FHWA 2020-0001-0001—Manual on Uniform Traffic Control Devices; Revision

Comments on Proposed Changes

Figure 2D-24. Example of Weigh Station Signing - Conventional Road

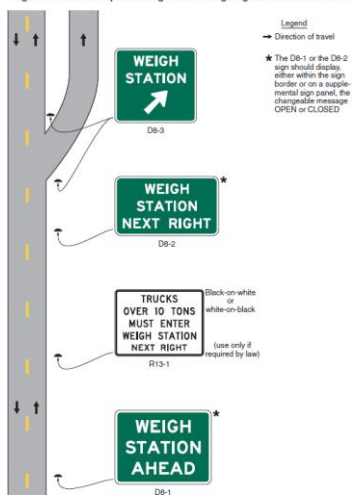
SC&RA supports the standardization of weigh station markings and wayfinding signs. As noted in a previous comment, many weight enforcement activities are now mobile and off site from physical weigh stations. SC&RA applauds this recognition of technological advancements in FHWA MUTCD policies.

The standard installation sequence of signing for a Weigh Station signing on a conventional highway shall include three basic signs (see Figure 2D-24):

- Advance Weigh Station Distance sign (D8-1) sign,
- Exit Direction Sign Weigh Station Next Right (D8-2) sign, and
- Exit Gore Sign Weigh Station Exit Directional (D8-3) sign.

When the WEIGH STATION legend of the D8 series signs is replaced with the COMMERCIAL VEHICLE INSPECTION AREA legend, as provided in Paragraph 6 of this Section, the WEIGH STATION legend of the R13-1 sign shall be replaced with the alternate legend INSPECTION AREA.

Figure 2I-9. Examples of Truck Parking Availability Signs

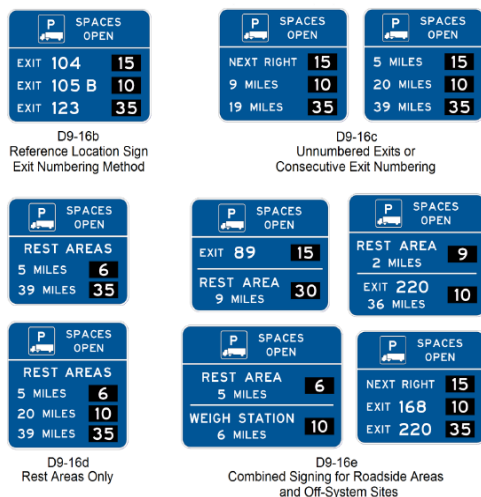
SC&RA supports standardization of digital truck parking and facility way finding signs. While recent changes to FMCSA Hours of Service rules for commercial vehicle drivers has introduced some flexibilities, the lack of safe truck parking remains a critical problem for our entire industry. Throughout the COVID-19 pandemic, many states loosened truck parking restrictions at state facilities to enable our operators the option to bobtail their load and seek rest accommodations offsite. A standardized information sign at these facilities would be useful.

The Truck Parking Availability General Service (D9-16b through D9-16e) sign (see Figure 2I-9) shall include a changeable message element with a white changeable legend on a black opaque background that displays only the number of parking spaces currently available at each location or the legend FULL.

The upper section of the sign shall display the Truck Parking (D9-16) symbol sign and the legend SPACES OPEN. The sign shall display the number of available truck parking spaces for no more than three parking facilities. Where two lines of legend, such as the location and a distance, are displayed for a parking facility, not more than two parking facilities shall be displayed on the sign. Where the truck parking facility is located off the main highway and is accessed from the crossroad, directional assemblies with the Truck Parking (D9-16) sign shall be installed along the ramp and along crossroads where the route to the facility requires a direction change, where it is questionable as to which roadway to follow, or where additional guidance is needed.
